Appl. No. 10/065,482
Amdt. dated January 09, 2006
Reply to Office action of October 20, 2005

Amendments to the Drawings:

REMARKS/ARGUMENTS

Fig. 1 Prior art

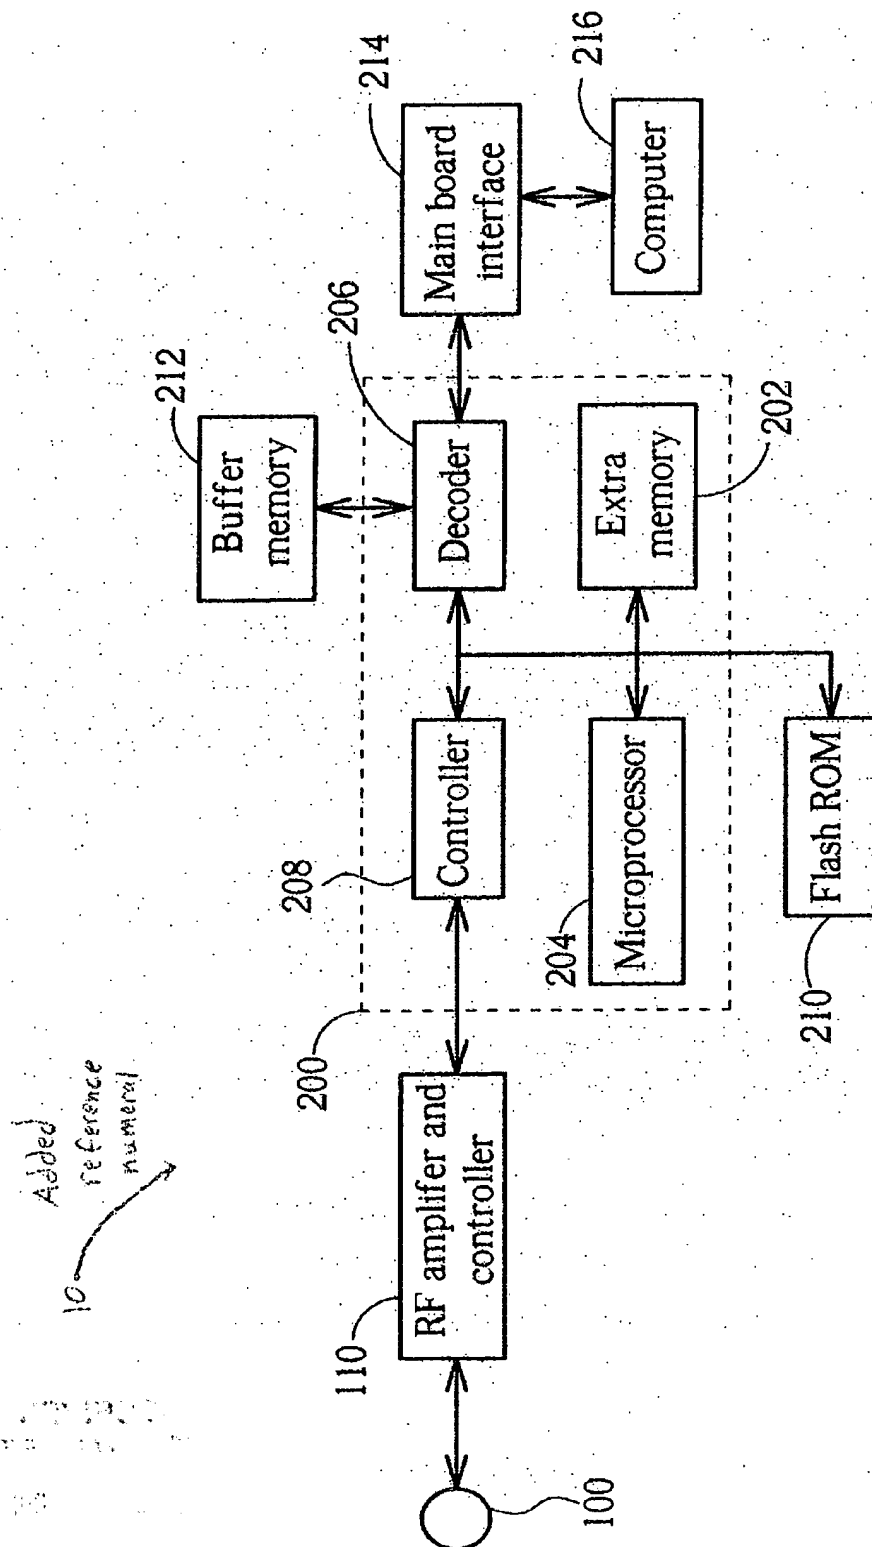
- 5 Figure 1 now contains reference numeral 10 to identify the optical disk system 10. Figure
4 contains reference numeral 20 to identify the optical disk system 20. In addition, the
reference numeral 200 has been replaced with 201 to distinguish the present invention
optical disk system control chip 201 having the control circuitry 500 from the prior art
optical disk system control chip 200. No new matter is added through these amendments
10 to the drawings or the specification.
